Applicant: Safeway/Carlisle Property

Name of Proposed Development: Rockwall Village No. 1

ROCKWALL VILLAGE ADDITION NO. 1

Re: Rockwall Village  
ROK 84812

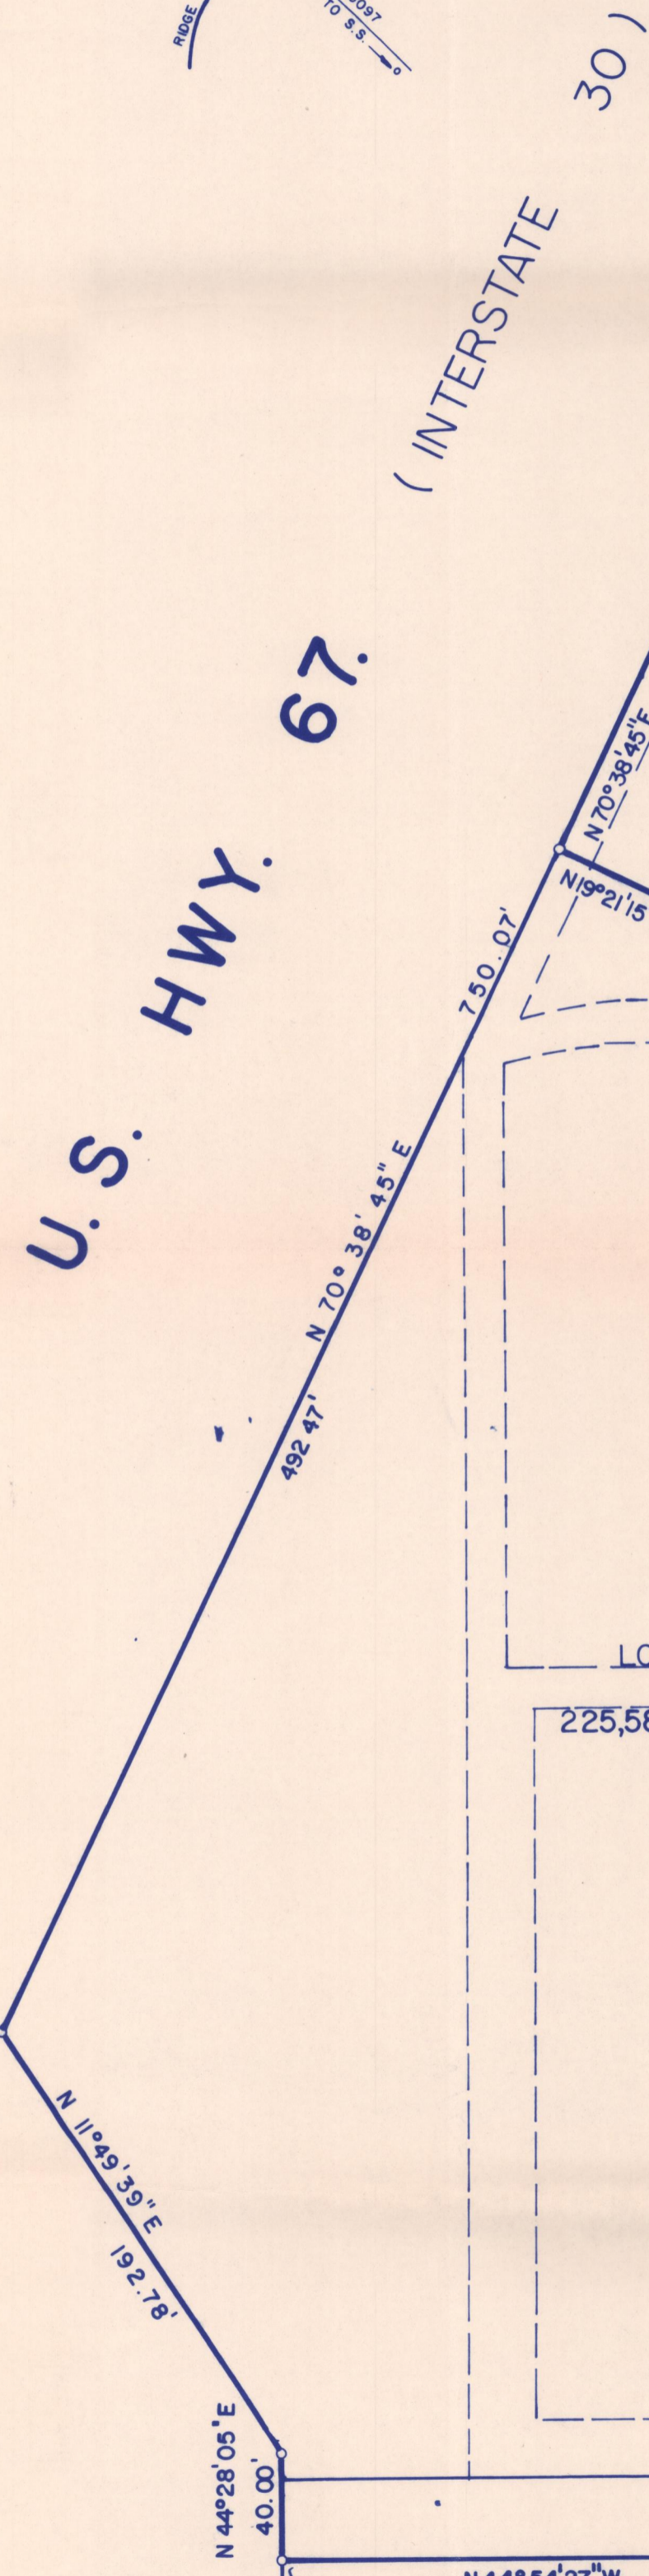
1. Change name of plat
2. Label easements
3. Change City signature area
4. Need 10 ft. additional easement or ROW on FM-740

*We need an easement 15' around all lots for telephone SW Roll*
